**CITY OF SAINT PAUL**  
Melvin Carter, Mayor

Date: July 12, 2019  
To: Comprehensive and Neighborhood Planning Committee (CNPC)  
From: Mike Richardson, Lucy Thompson and Menaka Mohan  
Subject: Design Standards Amendment to the *Ford Site Zoning and Public Realm Master Plan*  
– Recommendations Based on Public Testimony and Staff Comment

1. Public Comment for Ford Design Standards Draft and Related Text Amendments
2. Recommended Changes to the Ford Design Standards Draft and Related Text Amendments (red-line version)

### Mississippi River Boulevard Frontage

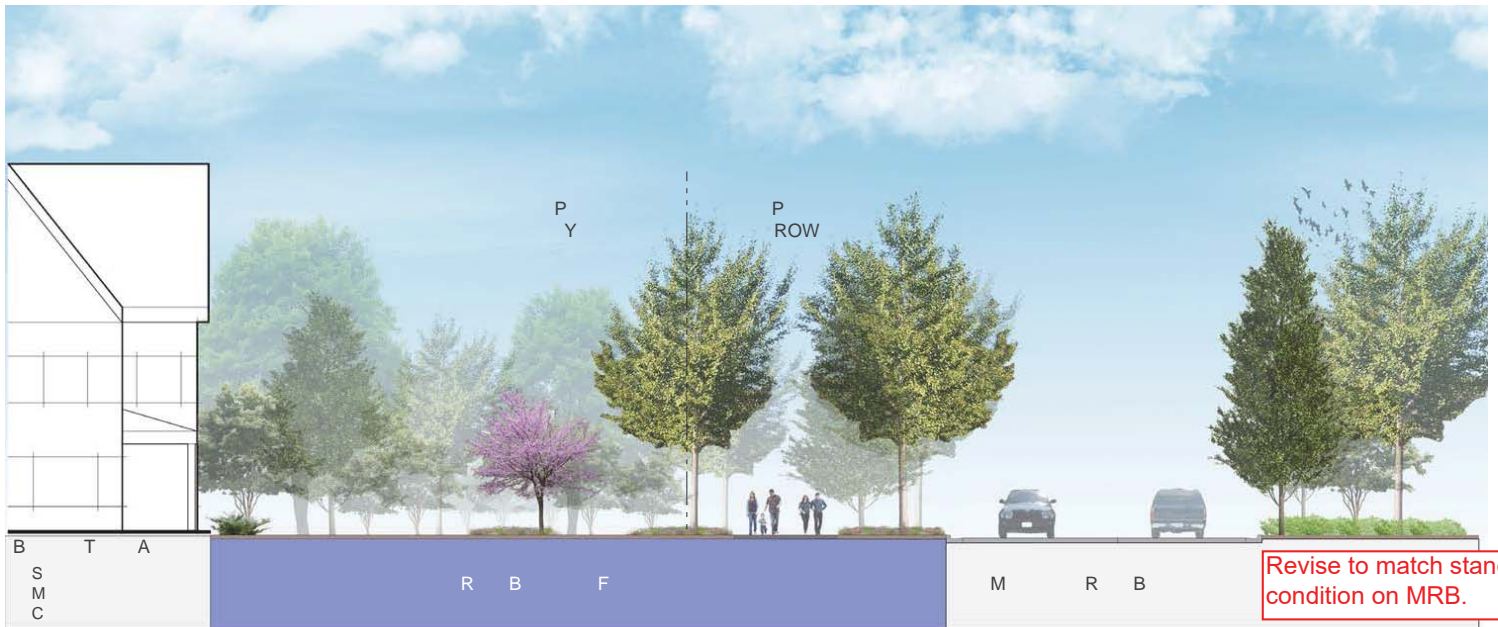
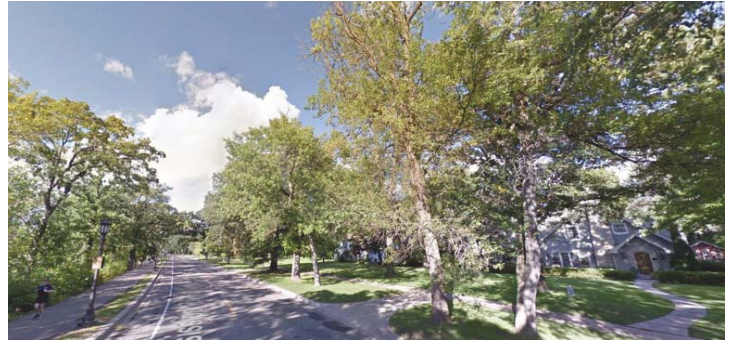
Revise to match standard condition on MRB.

Illustrative section to indicate areas of public access. Does not represent correct scale or final design. <sup>4</sup>

Number: 3 Author: richarmi Subject: Text Box Date: 7/12/2019 1:28:24 PM  
**Revise to match standard condition on MRB.**

Number: 4 Author: richarmi Subject: Text Box Date: 7/14/2019 9:38:46 AM  
**Illustrative section to indicate areas of public access. Does not represent correct scale or final design.**

### Mississippi River Boulevard South Frontage

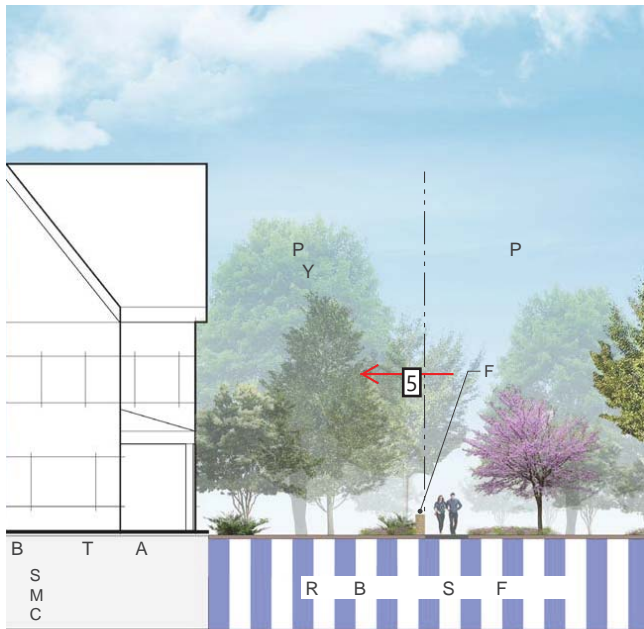
Illustrative section to indicate areas of public access. Does not represent correct scale or final design. <sup>6</sup>

Number: 6 Author: richarmi Subject: Text Box Date: 7/14/2019 9:38:35 AM  
**Illustrative section to indicate areas of public access. Does not represent correct scale or final design.**

### 8. **Building Standards for Parking Structures** 9

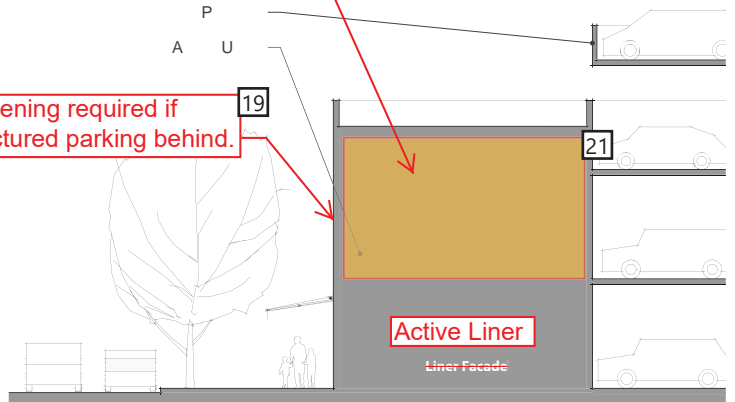
12. Modify diagram to say structured parking or active use.

19. Screening required if structured parking behind.

- 
- Number: 9 Author: richarmi Subject: Inserted Text Date: 7/14/2019 5:36:54 PM  
Structured Parking
- 
- Number: 10 Author: richarmi Subject: Inserted Text Date: 7/14/2019 8:09:24 PM  
65 (and revise diagram to indicate lower 12' of building)

### Urban Center/Diagonal Way Frontage Frontage Standards

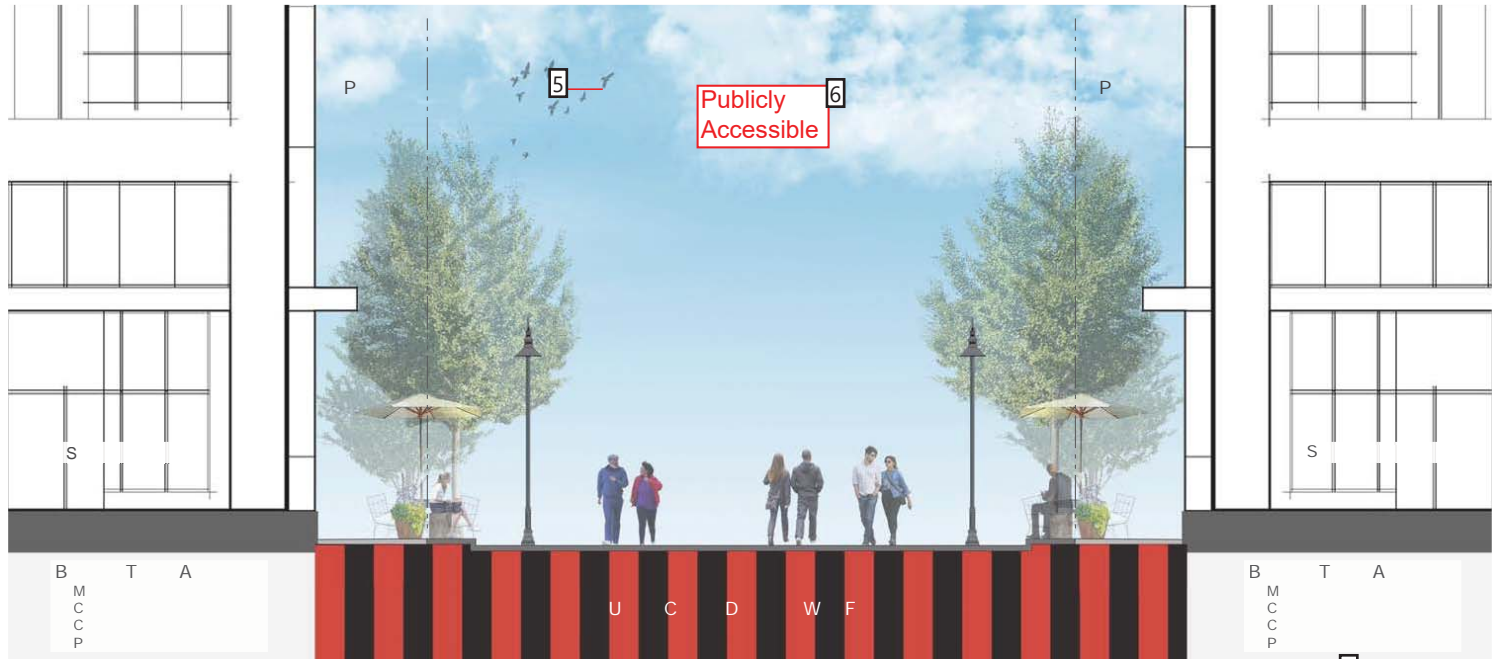
Illustrative section to indicate areas of public access. Does not represent correct scale or final design. 7

- ☰ Number: 7 Author: richarmi Subject: Text Box Date: 7/14/2019 9:39:15 AM  
**Illustrative section to indicate areas of public access. Does not represent correct scale or final design.**

### Urban Center/Residential Frontage

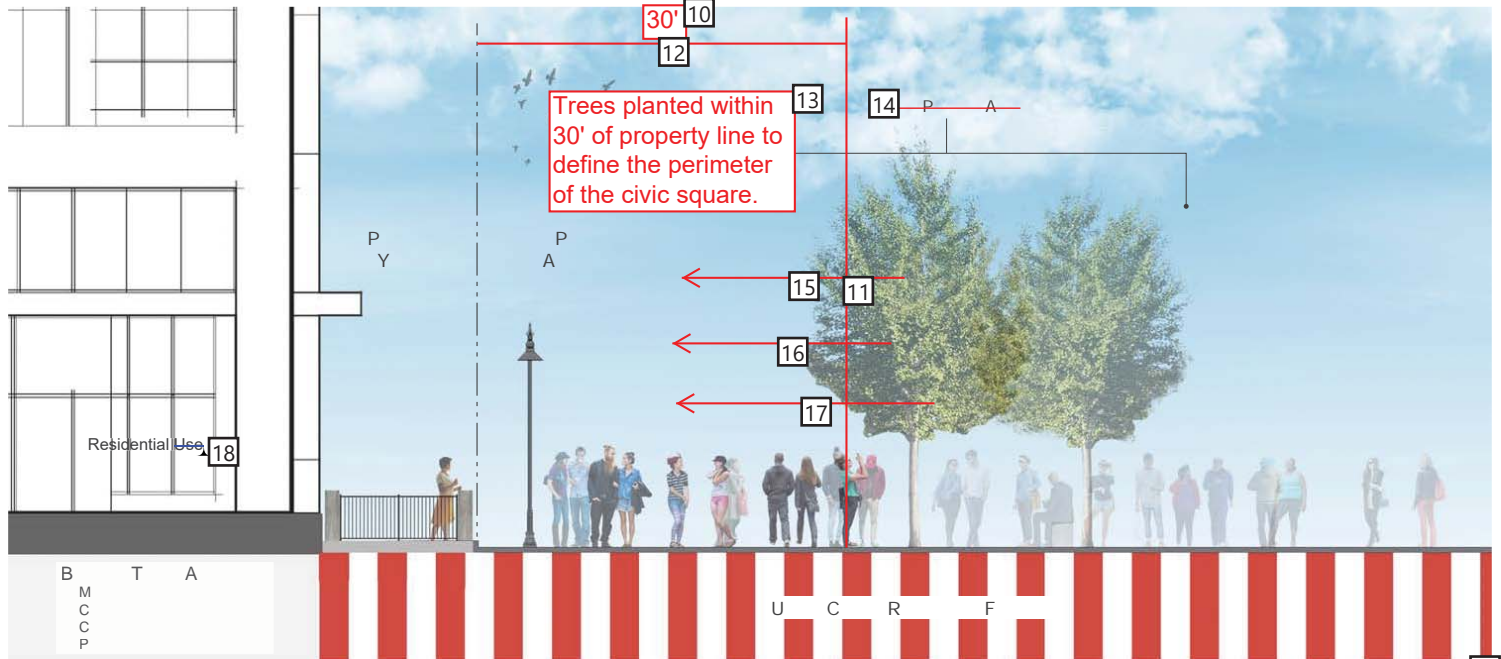
- 
- ✖ Number: 9 Author: richarmi Subject: Cross-Out Date: 7/14/2019 8:13:01 PM  
Modified S32 addresses this: "Trees shall define the perimeter of the civic square and must be planted within 30' of the adjacent property line."  
Revise/clarify diagram below.

**Trees planted within 30' of property line to define the perimeter of the civic square.**
- 
- ✖ Number: 14 Author: richarmi Subject: Cross-Out Date: 7/14/2019 8:13:27 PM

## Gateway West Frontage

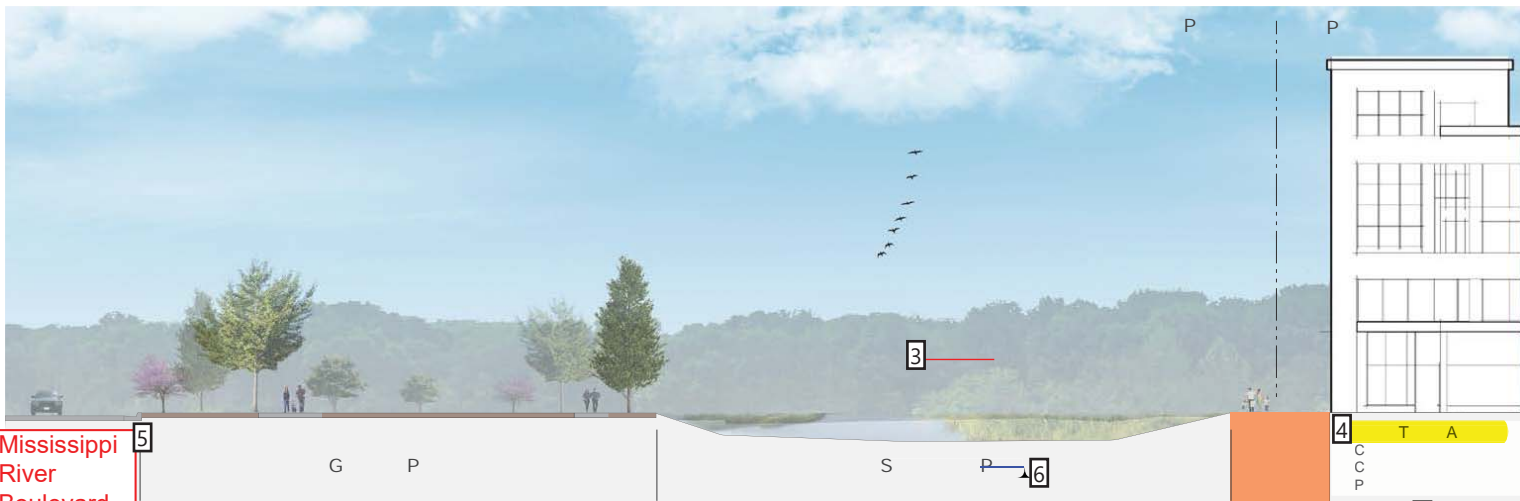
Illustrative section to indicate areas of public access. Does not represent correct scale or final design. <sup>7</sup>

Number: 7 Author: richarmi Subject: Text Box Date: 7/14/2019 9:39:34 AM  
**Illustrative section to indicate areas of public access. Does not represent correct scale or final design.**
